Reindeer Project Construction Services, Savoonga
EDA Project Number 07 79 07873

Addendum #3
7/10/2024

Summary of items included in this addendum:

1.1 LIFTING LOOP

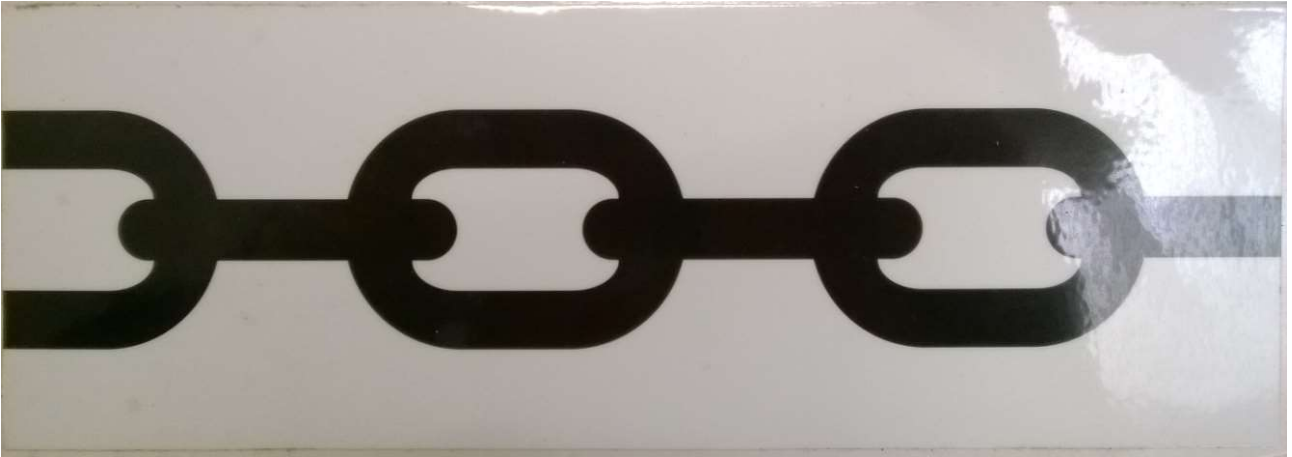
When attaching the slings to the module frame, mounting lugs (locks) are used
Each module is equipped with 12 similar grips: 4 on each side and 2 on each end.
